LiDAR Quality Assurance (QA) Report
San Francisco Bay LiDAR Project
NOAA Coastal Services Center
April 21, 2011

1 Executive Summary

The following LiDAR quality assurance report documents Dewberry's 3rd review of LiDAR data and derived products for the San Francisco Bay LiDAR Project. The data was flown by Fugro EarthData, Inc (FEDI) for the NOAA Coastal Services Center. The delivery of the data includes portions of seven California counties: Alameda, Contra Costa, Marin, Napa, San Francisco, Solano, and Sonoma.

Figure 48 - DEM colored by elevation in Global Mapper of tile c5550_42240 showing a floating Tidal hydrographic feature.

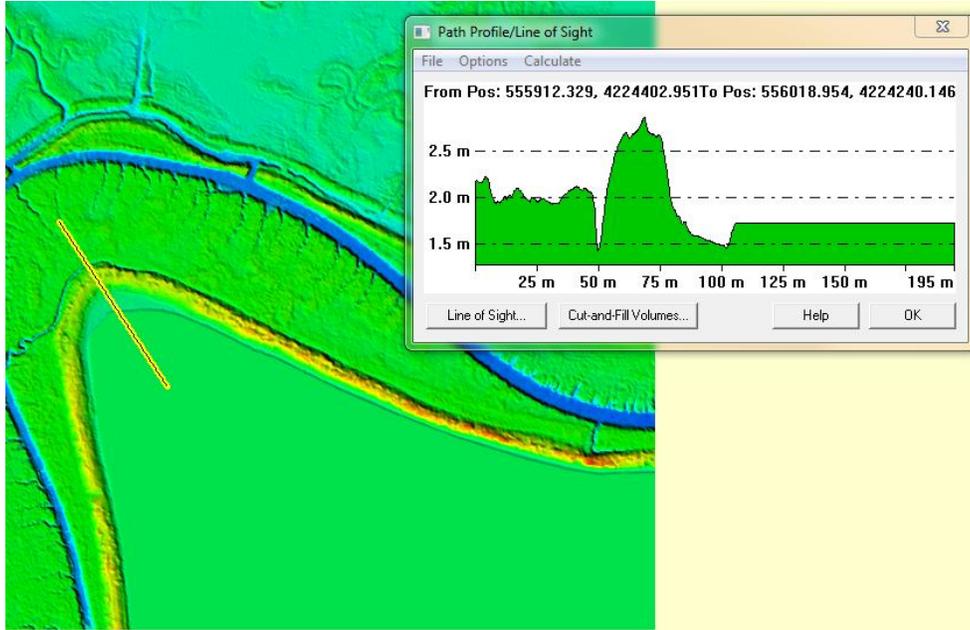
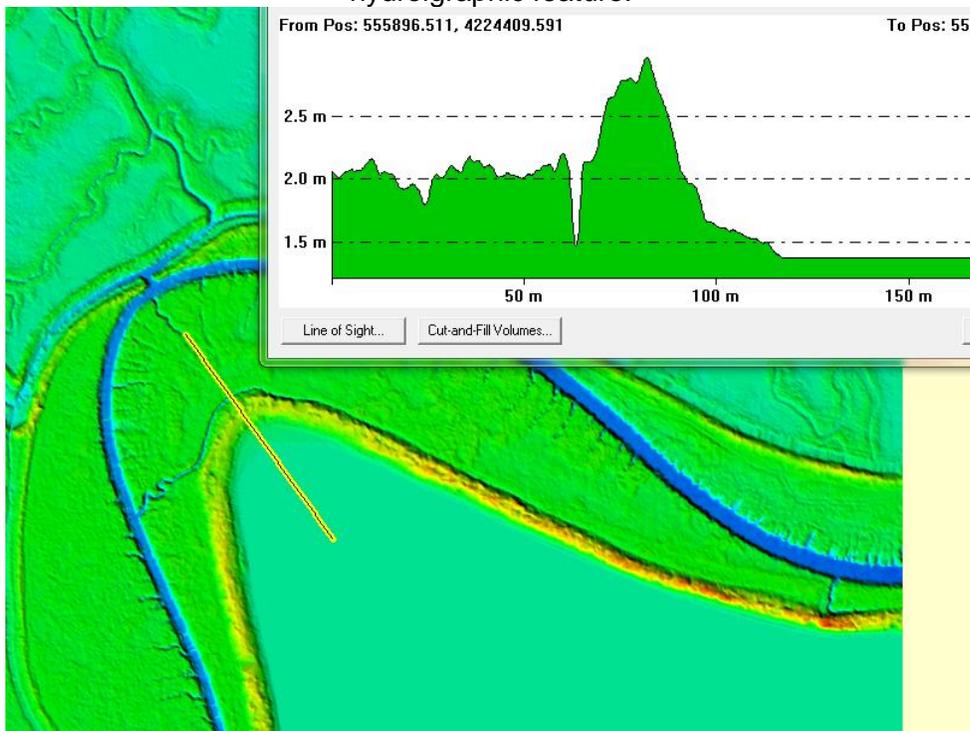
Several images are provided below to show how FEDI addressed floating vertices from previous deliveries (Figure 48 and Figure 49).

Figure 49 – DEM colored by elevation in Global Mapper of tile c5550_42240 from the 3rd delivery showing that the water body no longer floats.

Figure 50 - DEM of tile C5700_42150 from the 1st delivery that shows numerous divots creating a linear feature that is not reflected in the LiDAR.

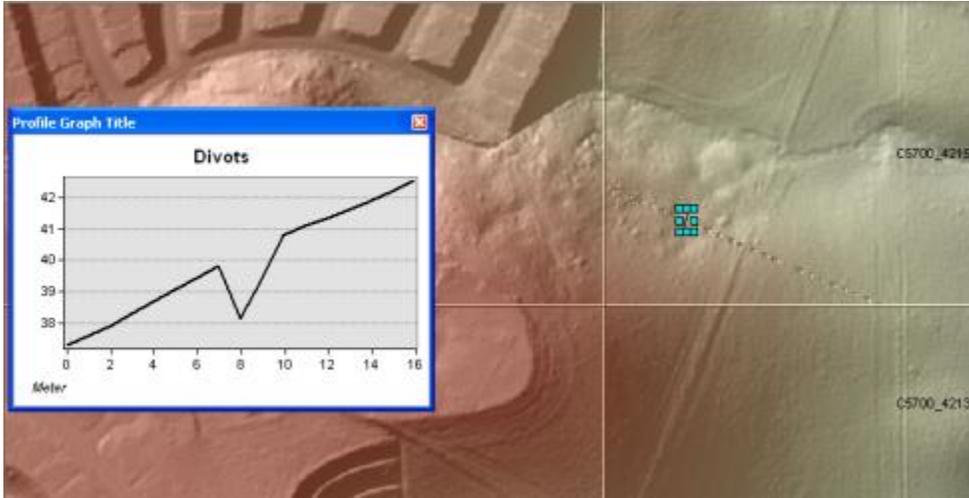
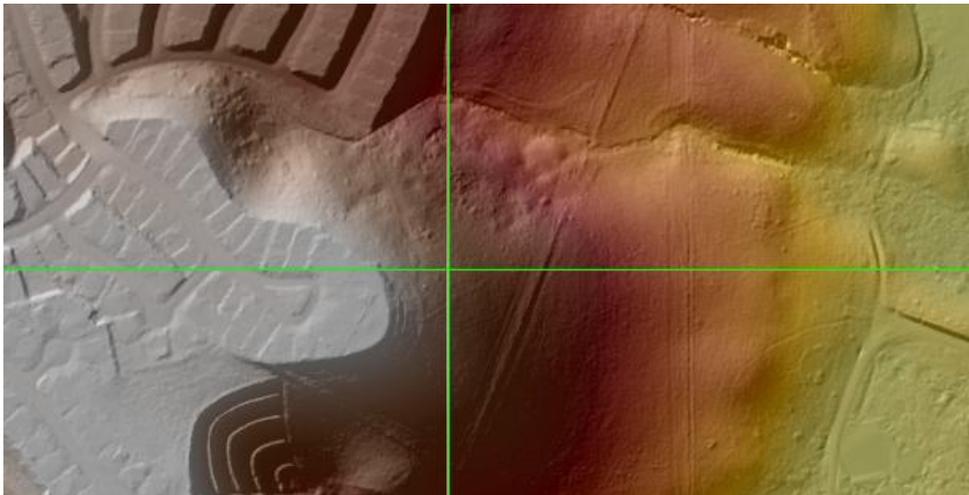
As this is the 3rd delivery, Dewberry only checked areas in the DEMs where calls were made from the initial delivery. Each tile was viewed in an ESRI environment with the addition of a Hillshade. Hillshades allow the viewer to see the DEMs as if in 3D. This helps errors or anomalies to be identified. All issues were addressed by FEDI in the 3rd delivery.

Figure 51 - DEM of tile C5700_42150 from the 2nd delivery that shows the linear artifact are no longer present in the DEM.
